U. S. NUCLEAR REGULATORY COMMISSION
REGION I

Report Nos. 50-220/88-09
50-410/88-09

Facility Name: Nine Mile Point Nuclear Station, Units 1 & 2

Inspection Summary: Inspection on March 7-11, 1988 and April 4-8, 1988
(Report No. 50-220/88-09, 50-410/88-09)

Date Pkg.: 2434-88A-288
Page 2 of 2
Exam Item: PIPE #5, PIPE #6
Procedure: 82A2434
Rev./F.C.: REV 3 FC 2
Title: UT PROCEDURE FOR THICKNESS MEASUREMENT

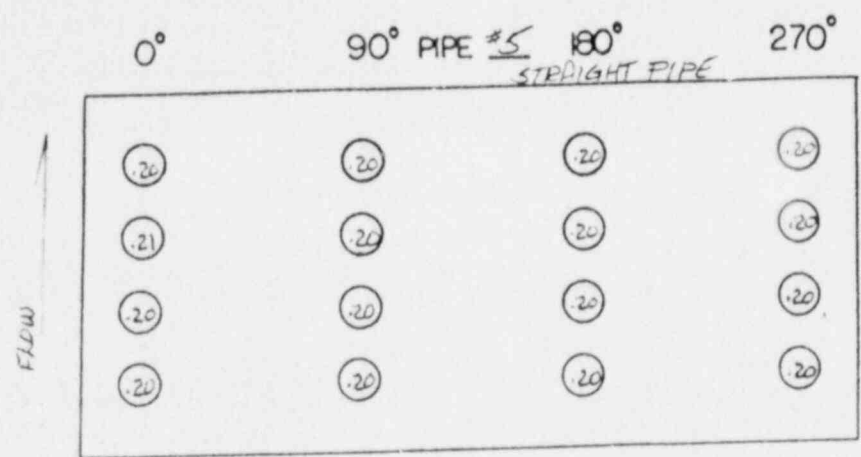
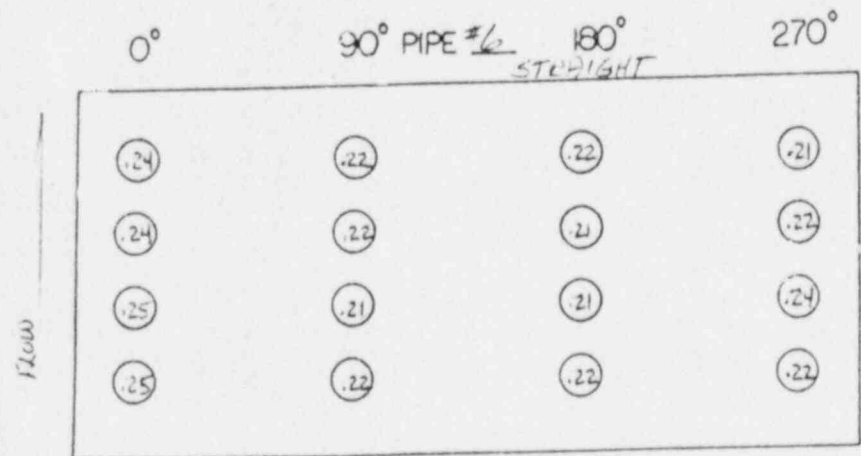
During inspection of above items a discrepancy was found with Nuclear Engineering Services (NES) report Nos. 2434-88A-289 and 2434-88A-288 in that the thickness data for areas 6 and 7 had been reversed. This indicates poor control over contractor activities, a major deficiency with regard to trending of ISI data and a failure to properly evaluate test results. Additional deficiencies in the licensee's trending of ISI data are identified in Section 5.2 regarding the balance of plant erosion-corrosion monitoring program and in Section 5.3 regarding torus shell thickness measurements.

NINE MILE 1 NUCLEAR POWER PLANT
UT THICKNESS MEASUREMENT GRID MAP FOR
EROSION CORROSION

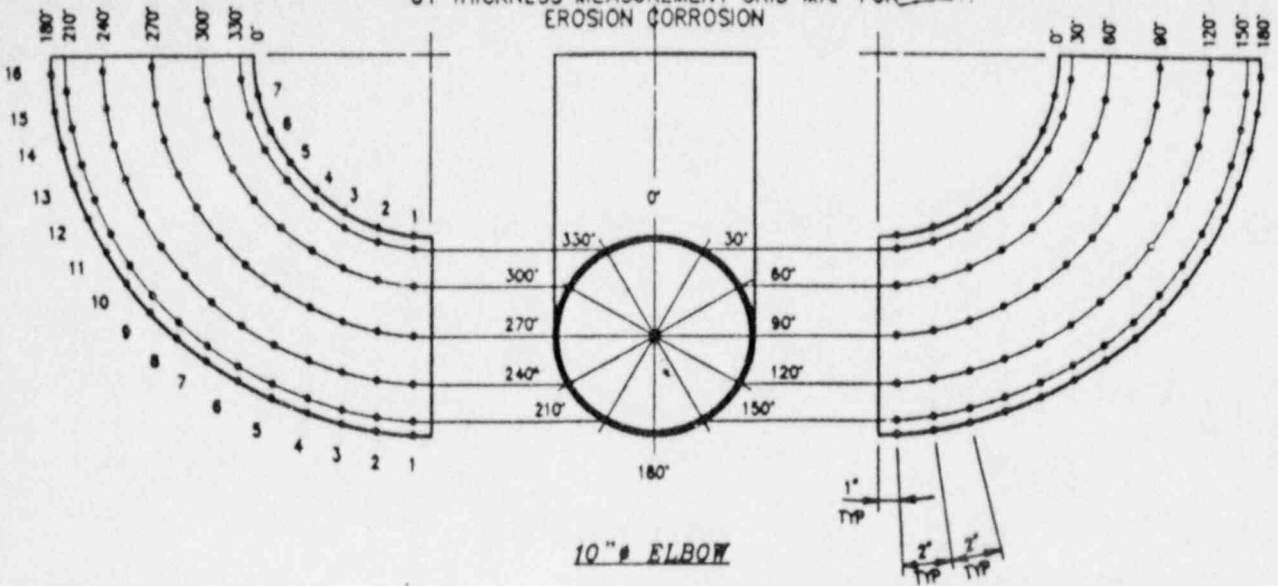
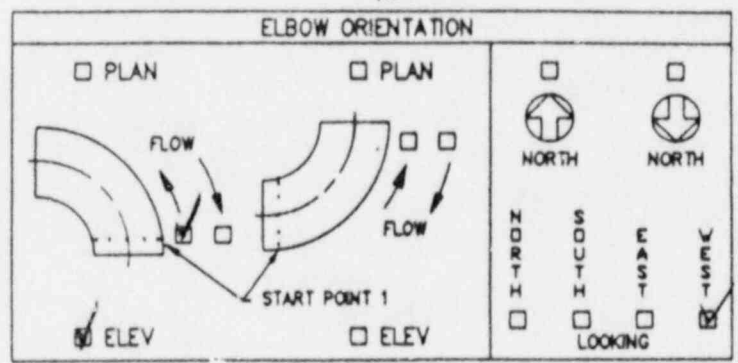
Three areas included in the licensee's balance of plant erosion-corrosion monitoring program were selected for independent measurements by the NRC inspectors. The areas selected are in the feedwater system and are identified as grid 6B and 6C with one area on a 2" pipe in between grid 6B and 6C. The NRC wall thickness data are presented in Attachment 2. Area 6C is on a 10" schedule 120 elbow with nominal wall thickness of 0.843", and a minimum allowed thickness of 0.737". The NES measurements of 6C are reported to two decimal places, and in three locations are listed as 0.73". It cannot be determined from those readings whether or not the minimum wall has been violated. The NRC readings are all above the minimum allowable thickness, but they represent fewer measurements than were made by NES. Additionally, NES reported the nominal thickness as 1" for area 6C. When that is reduced by 12½ percent, the minimum allowed thickness is 0.875". It is not clear at this time whether this is a reporting error or whether the nominal thickness of the elbow is actually 1".

During inspection of two areas "6B" and "6C" the inspectors found that the grid numbering system which was used on the piping was not consistent in that the grid was numbered in a clockwise direction at one end with numbers on the grid lines, and in a counterclockwise direction at the opposite end with numbers between the grid lines. The licensee uses two generic procedures (NES 80A2433 Revision 3 and CBI SI No. 1) to accomplish the task of taking and recording the ultrasonic thickness measurements. Neither procedure specifies how the grid will be numbered. The CBI Procedure calls for an "X" to be stamped as a permanent zero "degree" marker, but the relationship is not specified between this mark and in what order thickness measurement will be taken on the grid. Because of the lack of a specified system for taking data, the wall thickness measurements at a given location cannot be correlated from inspection to inspection and effective trending is not possible.

NIAGARA MOHAWK DATA
 TORUS THICKNESS MEASUREMENTS
 NINE MILE 1

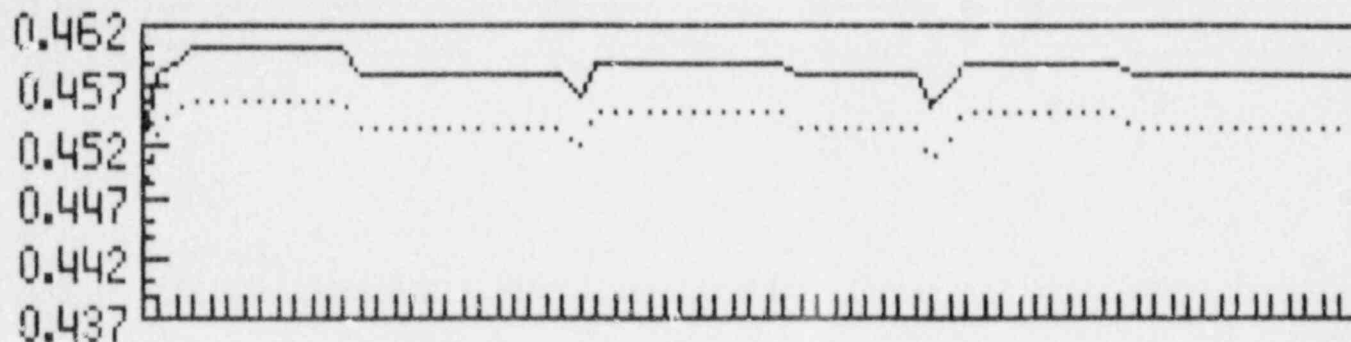
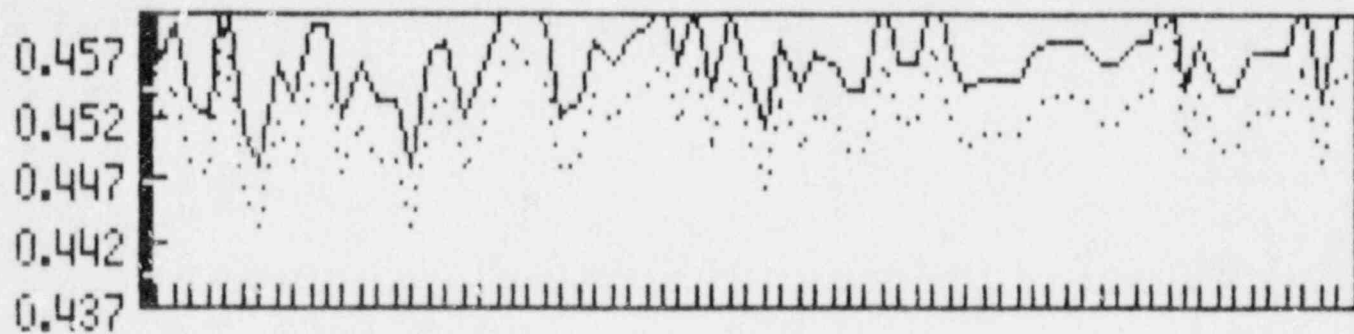
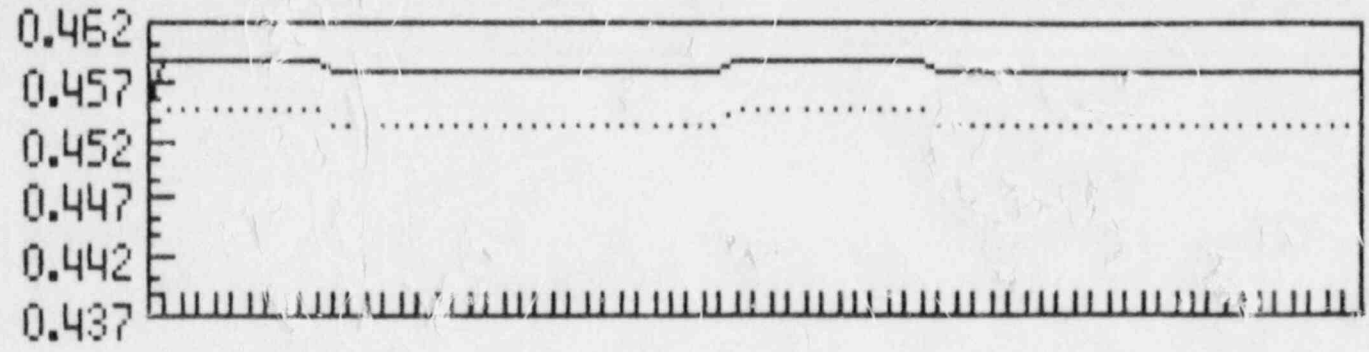
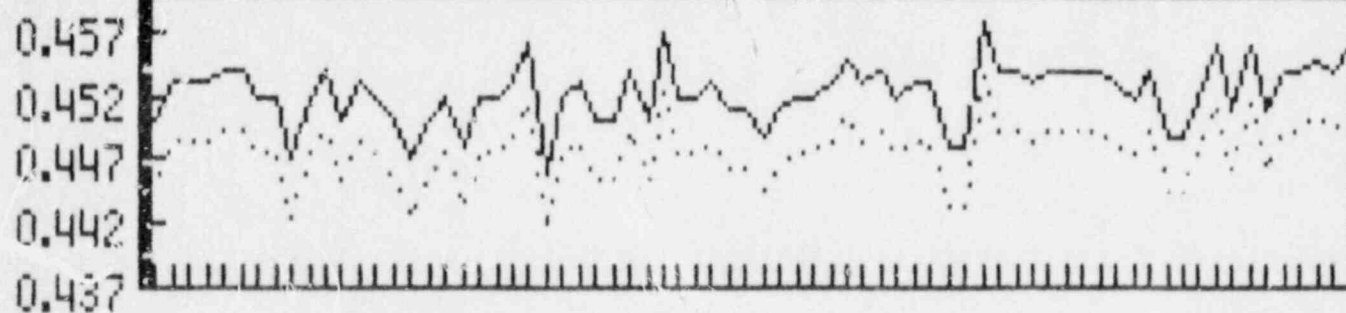
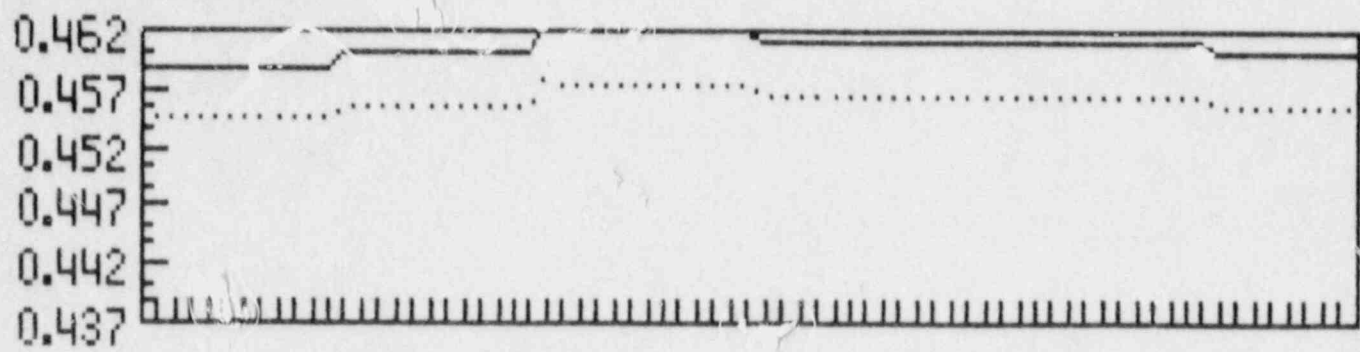
The NRC measured thickness data are presented in Attachment 3. Based on these data, several areas appear to be below or at the minimum specified wall thickness of 0.447". Those areas appearing to be close to or below minimum wall thickness were reexamined by one nuclear engineering services (NES) technician and one Niagara Mohawk auditor using two different ultrasonic thickness machines. Both technicians found the suspect readings acceptable but only by .003" (.450") on grid No. 1 of 5. If $\pm 1\%$ measurement error is applied, the result is measurements below or near minimum wall thickness. Furthermore, an allowance must be provided for continued wall thinning prior to the next inspection. The January 20, 1988 memo from L. M. McNeer to A. G. Vierling states that the estimated average rate of wall thinning is 0.0033 inch per year.

Applying the estimated 0.0033 inch per year rate of wall thinning to the measured wall thickness and considering measurement error indicates that the minimum specified wall thickness could be violated prior to completing another full cycle of operation.

Subsequent to the inspection, the licensee was requested to provide all torus wall thickness measurement data that had been previously taken. Seven sets of data, dating back to October 1975, were provided. These data were reviewed in the Region I office. The licensee also was requested to provide historical trend plots for these data but indicated that such plots did not exist. Review of the data revealed several inconsistencies. First, thickness measurements were not consistently taken at the same grid locations from one inspection to the next. Second, in two years (1984 and 1986) the data were only recorded to two decimal places. The lack of consistent measurement techniques reduced the effectiveness of the data for the purposes of trending and represents inadequate control over this special measurement process. Further, proper evaluation of this data would have disclosed the inconsistencies and prompted corrective actions.

A major weakness was identified in that torus shell data were not consistently reported or properly evaluated. At times the data were reported to three decimal places and other times two decimal places. Additionally, the measurements were not taken at the same locations from one inspection to the next. Reporting errors regarding safety related closed loop cooling piping measurement data were identified in that data for two areas were reversed. Additionally, balance of plant piping measurement data were taken on a grid pattern, but there was no control over grid numbering, or in what order the thickness measurements will be taken on the grid.
